# Control of Air Pollution from Motor Vehicles: Tier 3 Motor Vehicle Emission and Fuel Standards

## Summary and Analysis of Comments

Assessment and Standards Division  
Office of Transportation and Air Quality  
U.S. Environmental Protection Agency

**Figure 6-3**  
**NPRM MOVES NLEV (Passenger Car) Sulfur Impact**  
**Running Exhaust NOx, Normal Emitter**

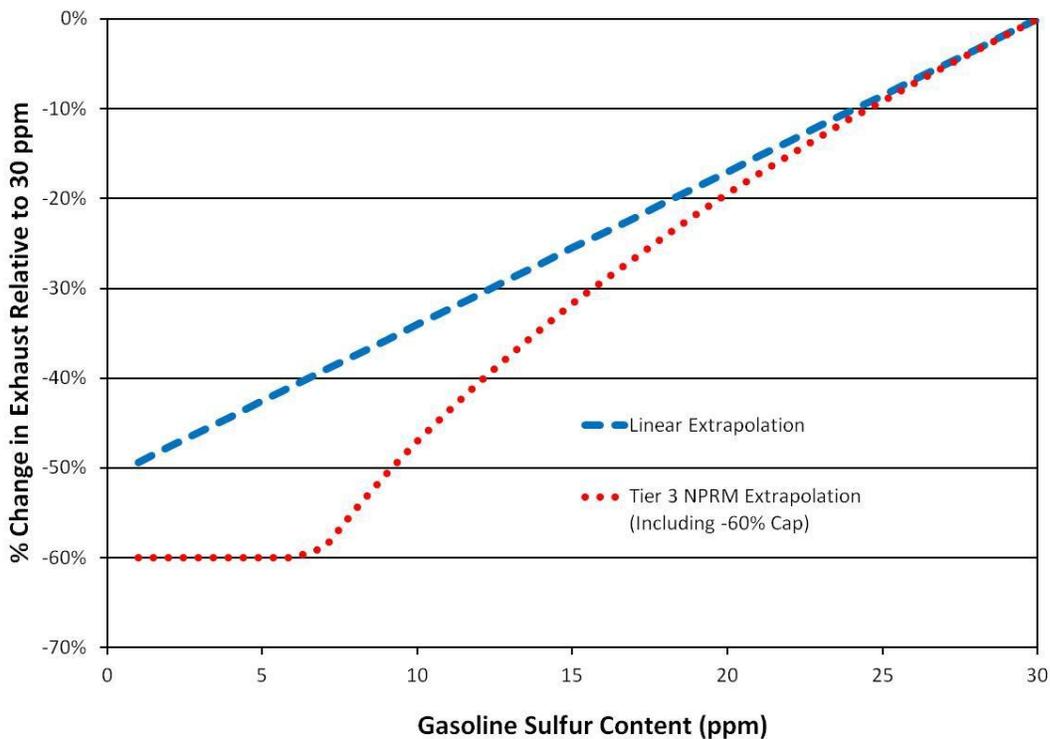
NPRM MOVES incorporated no new data for estimating 2003 and older model year vehicle fuel sulfur impacts. In order to evaluate fuel sulfur levels at or below 10 ppm as part of the regulatory evaluation, the model simply extrapolates preexisting sulfur adjustment equations present in the public version of MOVES. Thereby, the NPRM MOVES model methods are that of MOVES2010a with one minor change. Because this sulfur correction is an extrapolation (most of the underlying methods developed did not contain any fuels below 30 ppm S, see Table 6-5), EPA programmed in a cap at the maximum allowable exhaust reduction due to sulfur below 30 ppm. In MOVES2010a that cap is 15 percent (defined relative to 30

ppm fuel); in NPRM MOVES that cap is 60 percent (defined relative to 30 ppm fuel).<sup>72</sup> EPA’s justification is that the in-use sulfur test program with Tier 2 vehicles showed reductions up to 60 percent; therefore, greater reductions should be permissible when extrapolating previous test programs beyond the lower sulfur limit tested.

Figure 6-3 presents an example of how the linear extrapolation compares to that used by NPRM MOVES for NOx emissions from normal emitting NLEVs (passenger cars).

In modeling the emissions impact from the proposed rule, we did not attempt to update the fuel sulfur algorithm in MOVES for the pre-2004 model year vehicles because we were not aware of any additional data that provided information on fuel sulfur below 30 ppm for the legacy vehicles. Therefore, the commenter is correct that the effects of sulfur for pre-2004 model year vehicles are based on extrapolation.

However, the commenter did not accurately characterize the effect of extrapolation in the plot they presented above. Figure 3-10 through Figure 3-13 show the effect of sulfur on running exhaust emissions from pre-2004 model year vehicles for sulfur levels below 30 ppm, based on MOVES. The red lines represent the old sulfur floor of 15 percent, previously in MOVES2010a, and the blue lines represent the new sulfur floor of 60 percent in Tier 3 NPRM version of MOVES. For all pollutants, the lines lie on top of each other for sulfur level at or above 10 ppm, the average in-use sulfur level modeled in the Tier 3 rule. The two lines start to diverge only below 10 ppm. These trends are also true for the sulfur effects on starts. The plots indicate that the modification made to the sulfur floor in the Tier 3 NPRM version of MOVES did not affect the sulfur adjustment and thus, did not impact the emissions inventories estimated in the rule.

Figure 1. Cold-start NOx results for the EPAct Phase-3 Program, averaged by Aromatics Level (vol.%) and by Vehicle.

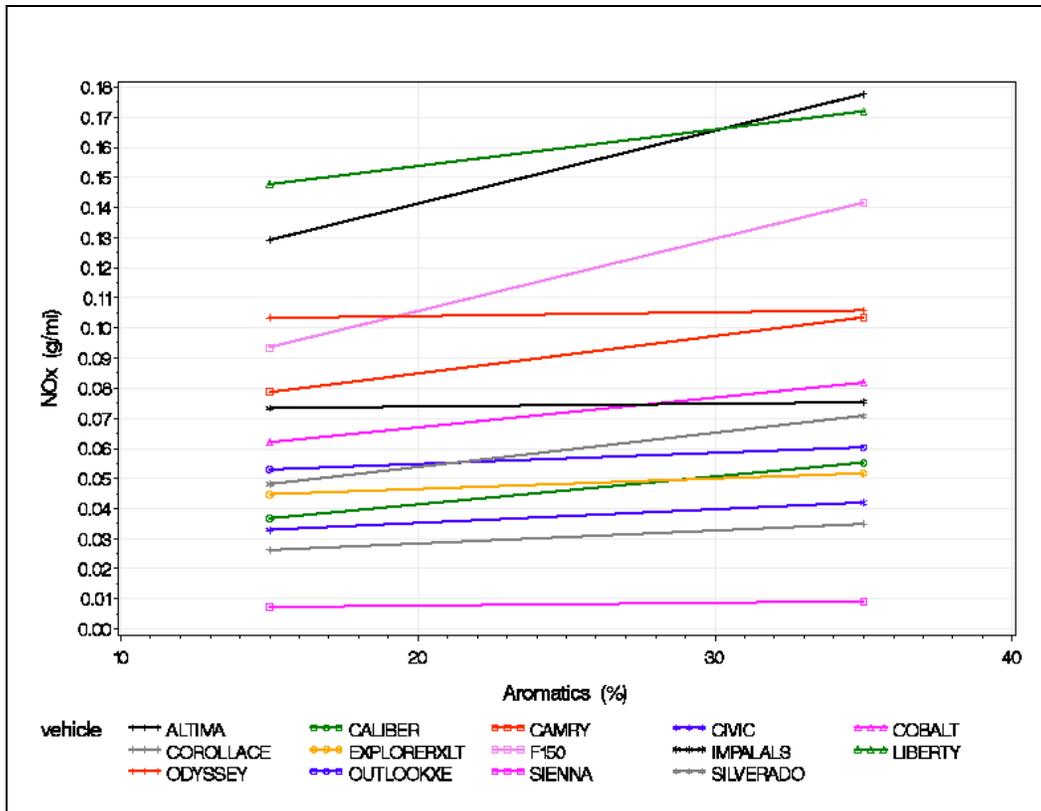
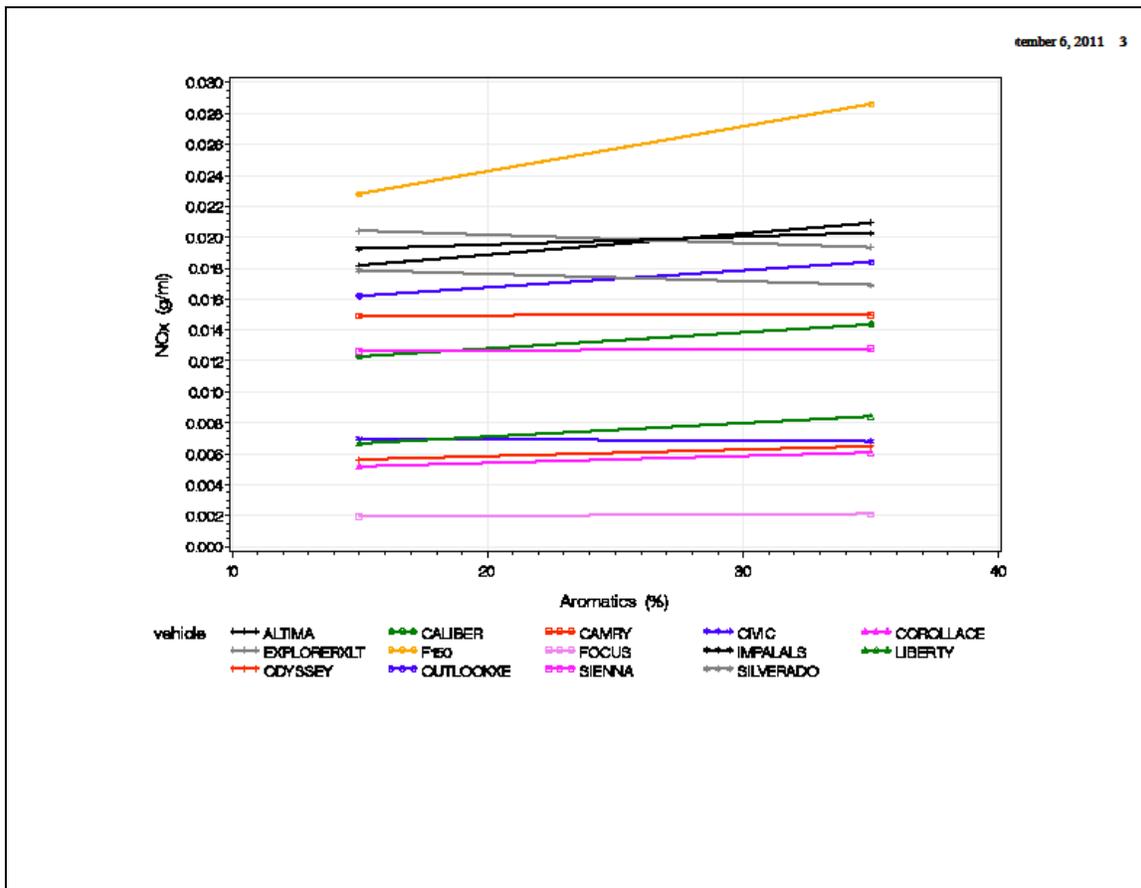
In addition, in contrast to most studies, the design for the EPAct study is well balanced between the two aromatics levels studied and the levels of the four remaining properties. When the results are averaged by vehicle and by fuel properties, the results suggest a notable increase in NO<sub>x</sub> for most vehicles, as shown in the figures below. For example, in Figure 1, which shows cold-start (Bag 1) NO<sub>x</sub> results averaged by vehicle and aromatics level, 13 of 15 vehicles show higher NO<sub>x</sub> at the higher aromatics level, with the remaining two vehicles showing no obvious change. This effect is also clearly visible when the results are averaged by the two aromatics levels and the levels of any of the four remaining fuel properties. Results are similar but not identical for hot-running (Bag 2) results shown in Figure 2. For running emissions, behavior by vehicle is more complex, with six of the vehicles showing a decline or no change by aromatics

level, but with the remaining vehicles showing increases. While this set of results suggests an increase in NOx on average, it also shows variability in vehicle responses, which may be attributable in some degree to measurement or random error, or also to differences in vehicle design, calibration or emission-control strategies.
